SICHERHEITSMITTEILUNG für Sprungfallschirme

Nummer: 05/2004

Betroffene Muster: ATOM MILLENIUM

Betrifft: Kontrolle der Klappe Nr.1 des Hauptschirmcontainers.

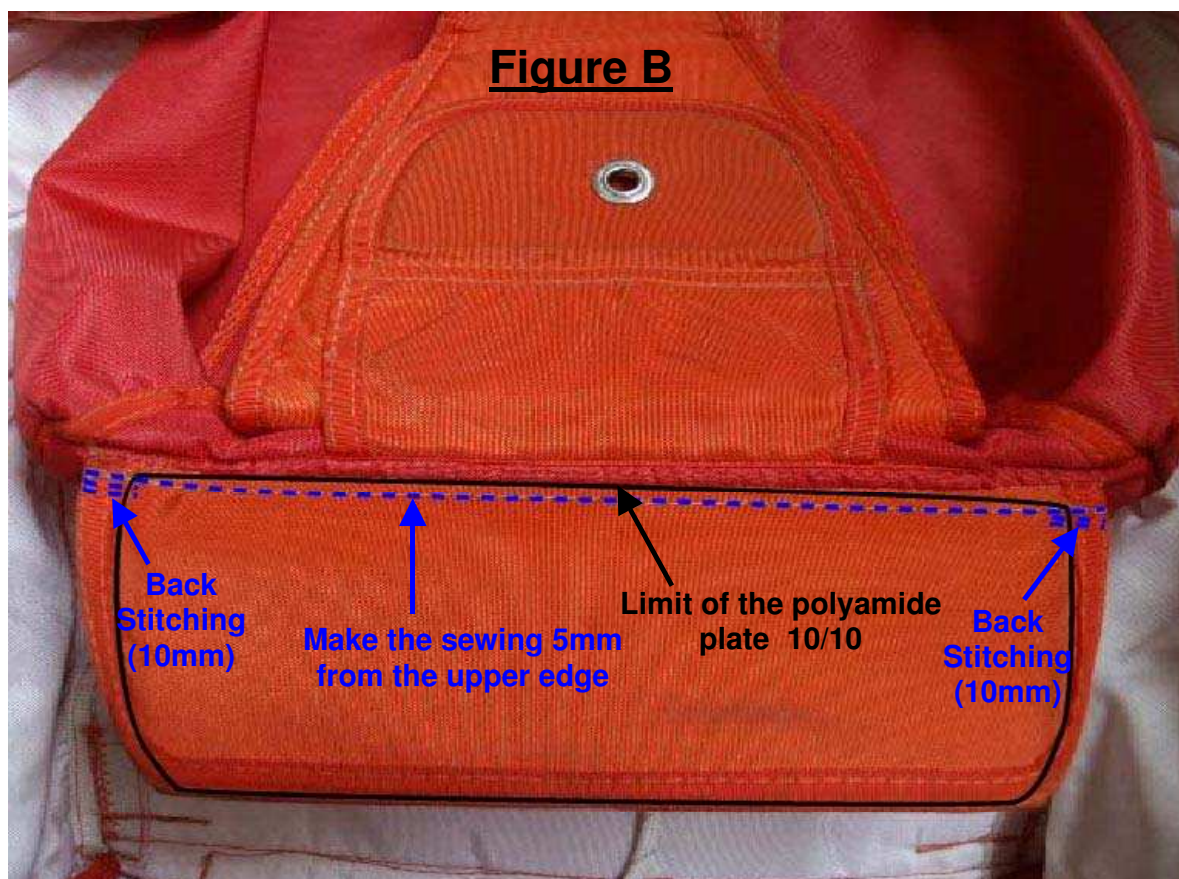
A deformation of the polyamide plate 10/10 (internal plate) of the deflector flap may occur near the sewing that binds the deflector flap to the container (see figure A).

Depending on the way the deflector flap is placed on the main deployment bag during the packing process, it may be deformed in time and its efficiency may be reduced.

Case N°1 : In the event of a deformation as shown on figure A : Before using the equipment again, get a qualified rigger to make a sewing on the deflector flap as shown on figure B.

Case N°2 : In the event of an absence of deformation : As a precaution, also get a qualified rigger to make a sewing on the deflector flap as shown on figure B during the next repacking of the reserve canopy at the latest.

Make a sewing all along the deflector flap (normal stitch) making sure that the polyamide plate 10/10 (internal plate) is included in the sewing. (The reserve canopy needs to be removed from the reserve container).

- Use polyamide thread 66 strength up to 6 kg (ref PF 9002402000 : Thread for container (30/3) or any equivalent),
- make 5 to 6 stitches every 2 cm,
- make it 5 mm from the edge,
- make two 10mm back stitching at the both ends of the sewing.

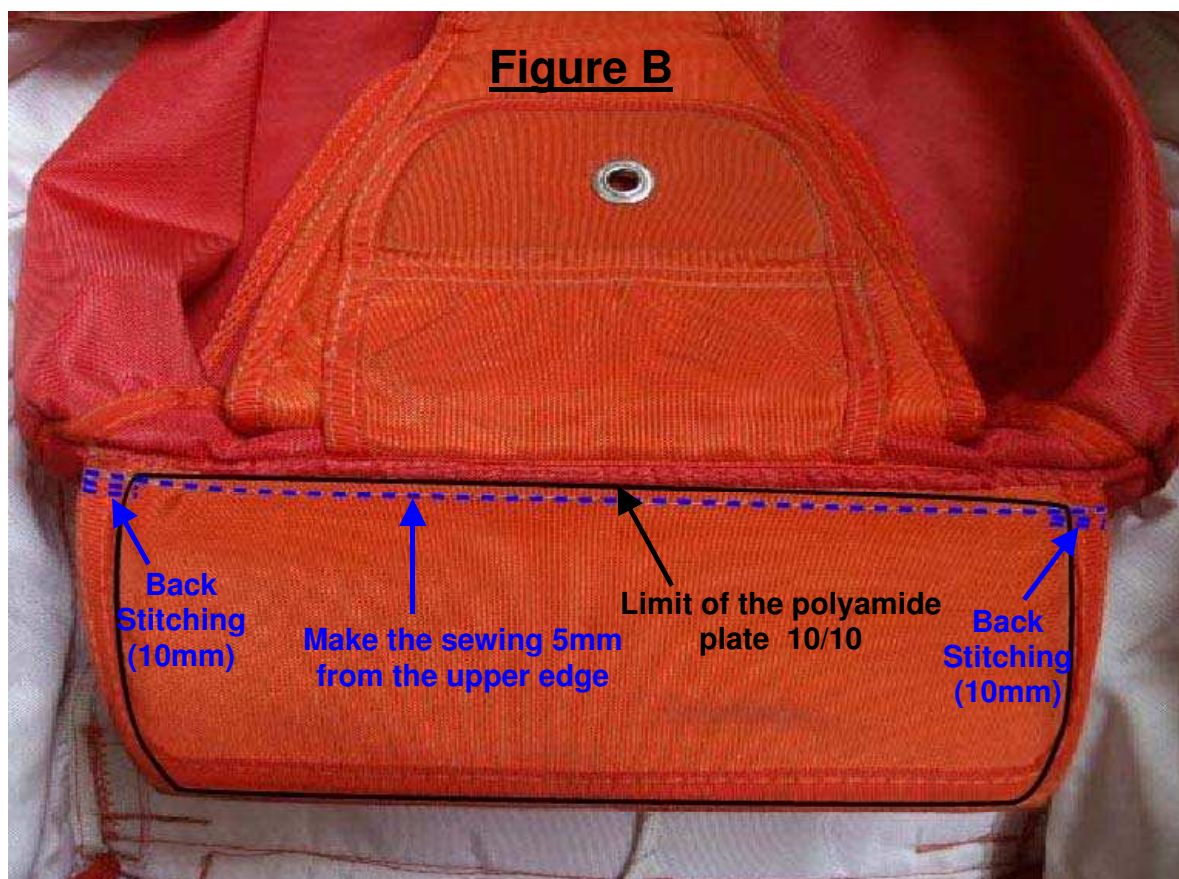
A deformation of the polyamide plate 10/10 (internal plate) of the deflector flap may occur near the sewing that binds the deflector flap to the container (see figure A).

Depending on the way the deflector flap is placed on the main deployment bag during the packing process, it may be deformed in time and its efficiency may be reduced.

Case N°1 : In the event of a deformation as shown on figure A : Before using the equipment again, get a qualified rigger to make a sewing on the deflector flap as shown on figure B.

Case N°2 : In the event of an absence of deformation : As a precaution, also get a qualified rigger to make a sewing on the deflector flap as shown on figure B during the next repacking of the reserve canopy at the latest.

Make a sewing all along the deflector flap (normal stitch) making sure that the polyamide plate 10/10 (internal plate) is included in the sewing. (The reserve canopy needs to be removed from the reserve container).

- Use polyamide thread 66 strength up to 6 kg (ref PF 9002402000 : Thread for container (30/3) or any equivalent),
- make 5 to 6 stitches every 2 cm,
- make it 5 mm from the edge,
- make two 10mm back stitching at the both ends of the sewing.
